Project	IEEE 802.16 Broadband Wireless Access Working Group < http://ieee802.org/16 >	
Title	Update of Figure 219 – OFDMA Frame With Multiple Zones	
Date Submitted	2004-05-04	
Source(s)	Lei Wang Cygnus Multimedia Communications, Inc.	Voice (760)448-1984 Fax: (760)448-1989 Email: lwang@cygnuscom.com
Re:	This is a contribution to IEEE 802.16e.	
Abstract	updated drawing of Figure 219.	
Purpose	Action item from the 16e TG.	
Notice	This document has been prepared to assist IEEE 802.16. It is offered as a basis for discussion and is not binding on the contributing individual(s) or organization(s). The material in this document is subject to change in form and content after further study. The contributor(s) reserve(s) the right to add, amend or withdraw material contained herein.	
Release	The contributor grants a free, irrevocable license to the IEEE to incorporate material contained in this contribution, and any modifications thereof, in the creation of an IEEE Standards publication; to copyright in the IEEE's name any IEEE Standards publication even though it may include portions of this contribution; and at the IEEE's sole discretion to permit others to reproduce in whole or in part th

Figure 219. Illustration of OFDMA Frame with Multiple Zones

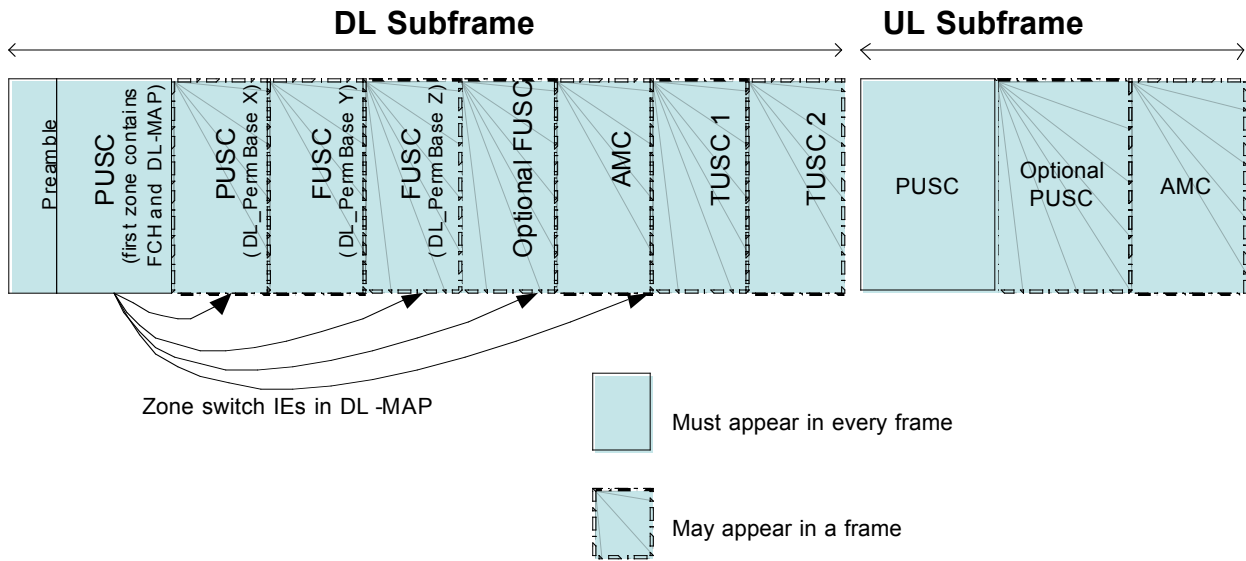
Replace Figure 219 with the following figure:
